# **CONNECTION ASSESSMENT & APPROVAL PROCESS**

*Project: Installation of a new 125MVar 128kV Capacitor Bank  
at Leaside TS*

***CAA ID No. 2002-EX043***

#### ***LEASIDE TS - Install New 125MVA<sub>r</sub> 128kV Capacitor Bank***

**DIAGRAM 2**

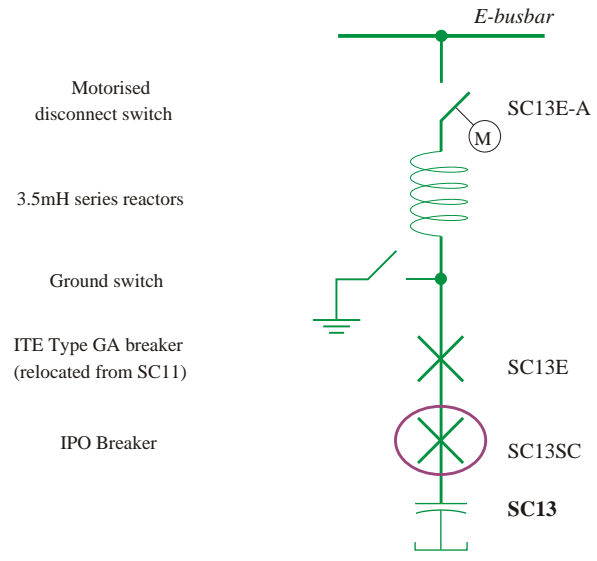
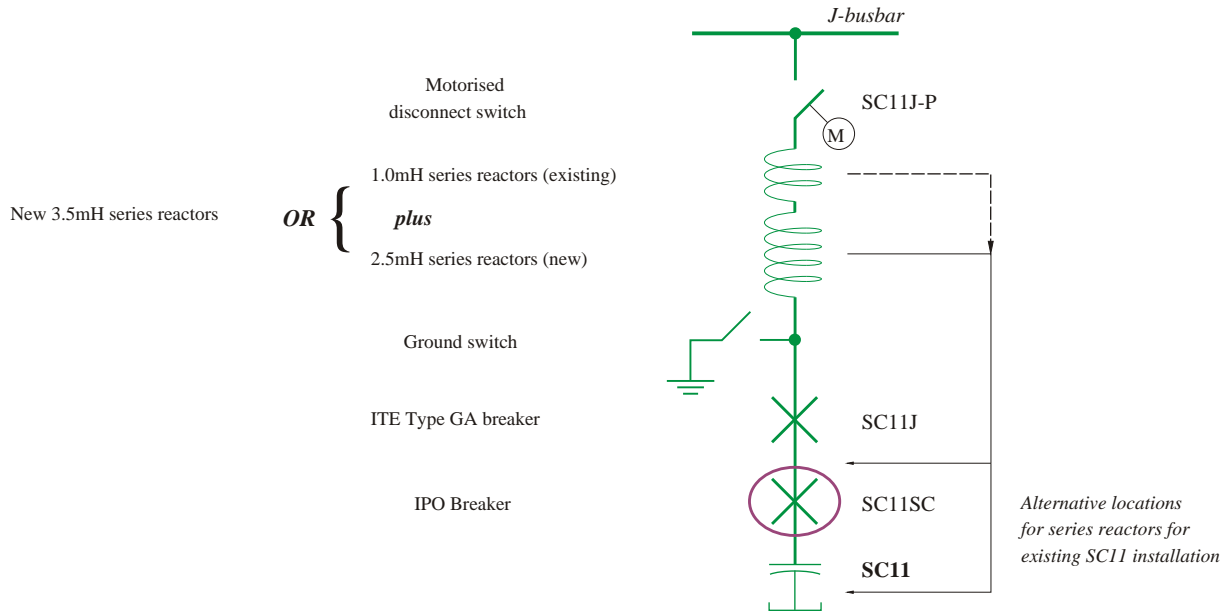
Series reactors rated at 3.5mH are to be installed on the new capacitor bank to limit the out-rush current from the individual capacitor banks due to close-in faults at Leaside TS. These are to be installed between the disconnect switch and the back-up breaker, as shown in Diagram 2.

The existing SC11 capacitor bank is already equipped with 1.0mH series reactors. These are either to be replaced with new 3.5mH series reactors or additional, complementary 2.5mH reactors are to be installed to provide a combined reactance of 3.5mH. The preferred location for the new 2.5mH or the replacement 3.5mH series reactors is between the disconnect switch and the back-up breaker. However, should space constraints preclude their installation in this location, then the preferred alternative would be between the two breakers.

In the event that the series reactors cannot be located at either of the positions above, then they would need to be installed either between the IPO Breaker and the SC11 capacitor bank, or in its neutral connection.

The new capacitor bank is to be connected to the E-busbar through a motor-operated disconnect switch, as shown in Diagram 2.

**DIAGRAM 3**

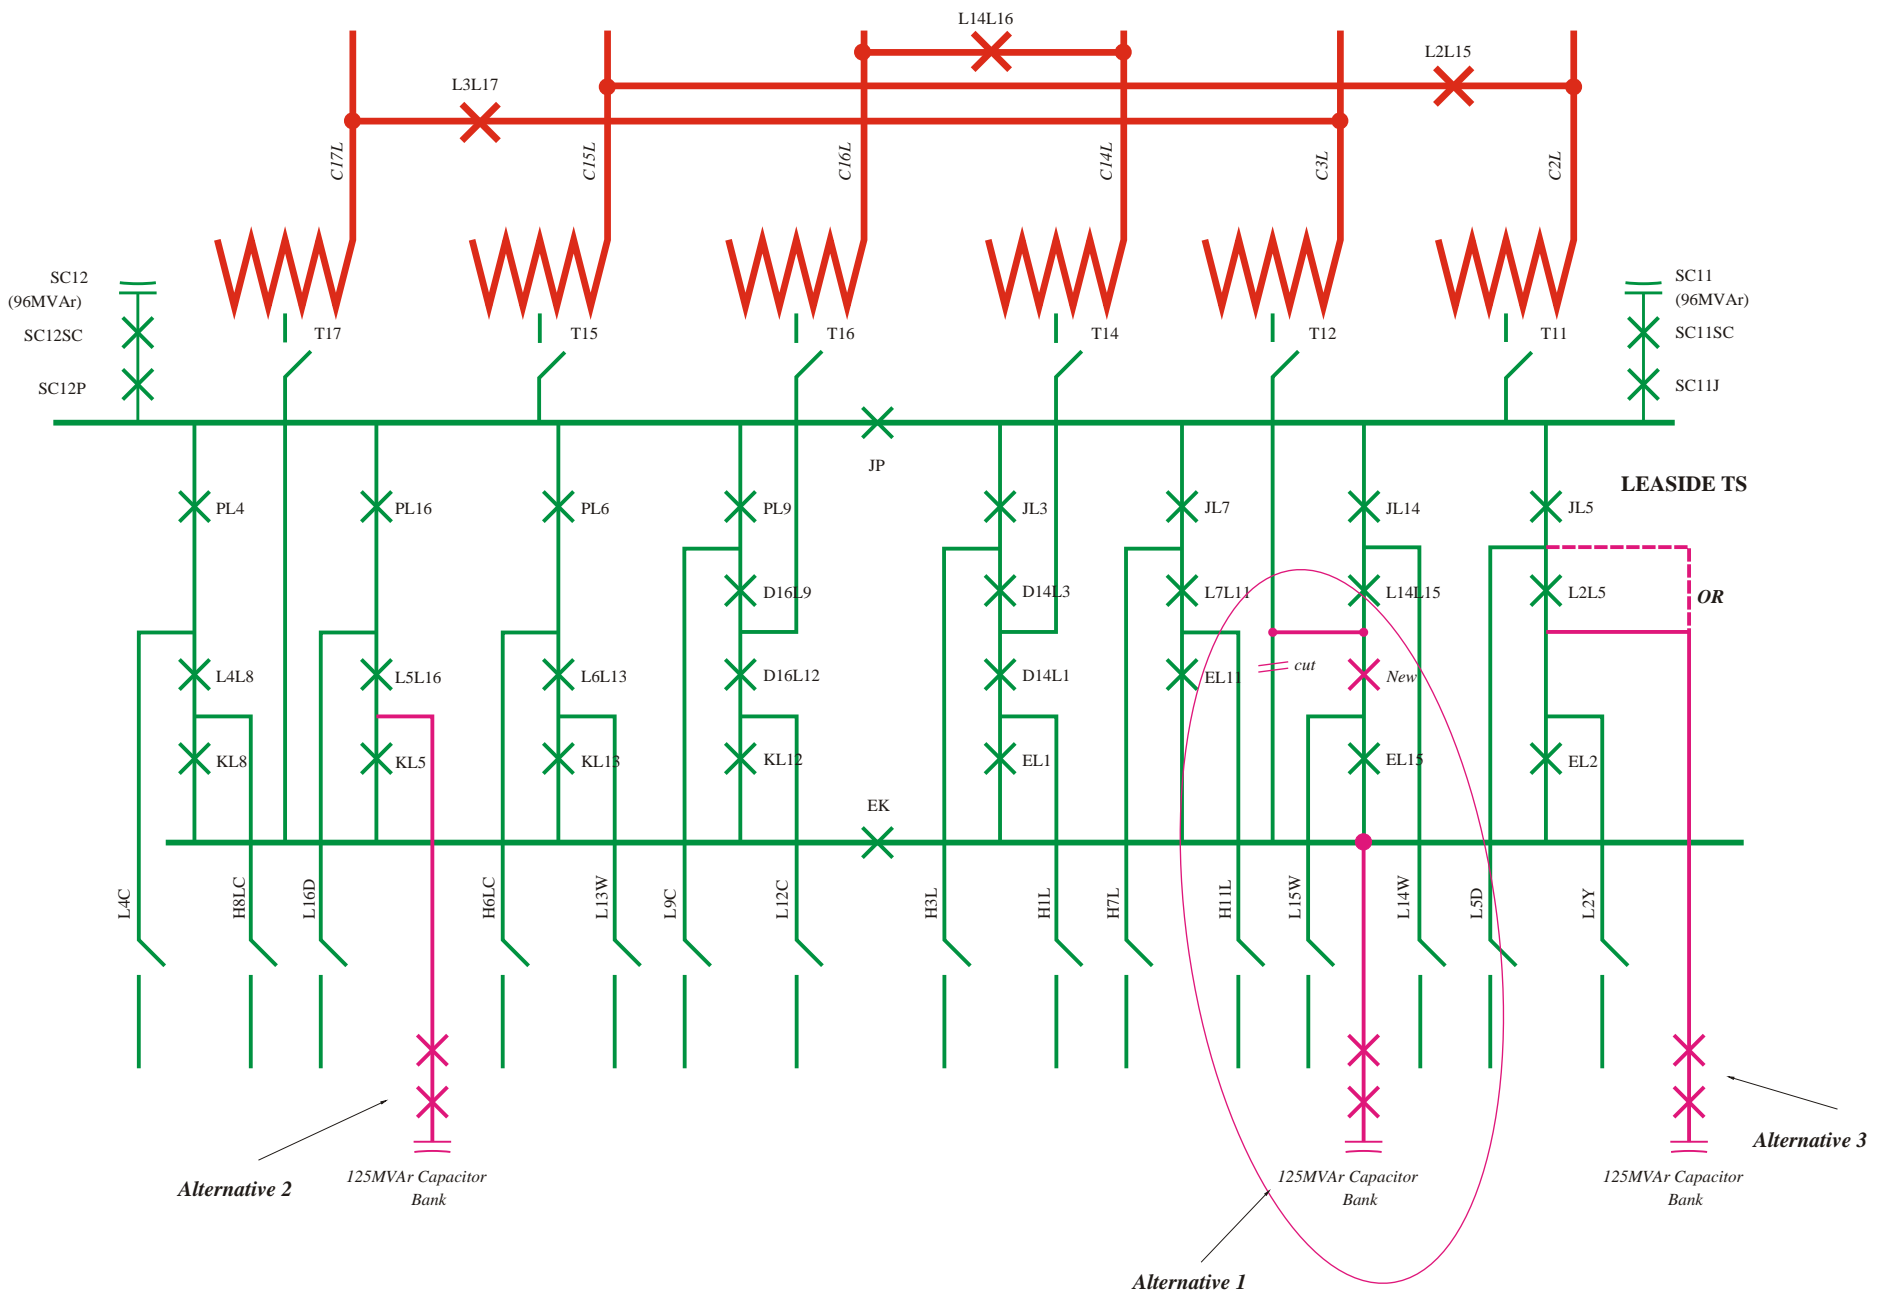
The arrangement that Hydro One has proposed for the connection of their new 125MVAR capacitor bank would extend this situation so that contingencies involving the 230kV circuit-transformer combination, C3L/T12, would also result in a similar loss of reactive support.

At the request of the IMO, Hydro One has reviewed the following alternatives that are shown in Diagram 3, to determine whether they could be adopted to avoid this situation:

- Install an additional 115kV breaker at Leaside TS so that transformer T12 could then be reterminated on to the centre position on the JL14 diameter.

- Connect the new capacitor bank to the idle position between breakers L5L16 & KL5

- Connect the new capacitor bank on to the same terminal point as the radial circuits L5D or L2Y

While Hydro One acknowledges that this would be the preferred arrangement in terms of system reliability, it would be very expensive to implement. This arrangement would require both an additional 115kV breaker to be installed in the existing diameter at Leaside TS and the retermination of the auto-transformer to be made via a cable because of space constraints in the switchyard.

Although this would be a suitable position for connecting a capacitor bank, studies have confirmed that the first new capacitor bank needs to be installed on the other half of the Leaside busbar. Hydro One is therefore proposing to install the second 125MVAR capacitor bank (in 2006) in this position.

Due to the age of the cables and the fact that the loads at Duplex TS (supplied via cable L5D) and Glengrove TS (supplied via cable L2Y) are not transferable, there are concerns that any over-voltages could damage the cables and would therefore result in an extensive supply interruption.

Since there is considerable uncertainty regarding future changes that could possibly occur at Leaside TS, it is proposed to approve the connection of the new 125MVAR capacitor bank at Leaside TS on to the E-busbar, but for the IMO to reserve the right to review the connection arrangement at a future date once decisions have been made regarding enhancements to the supply to downtown Toronto.
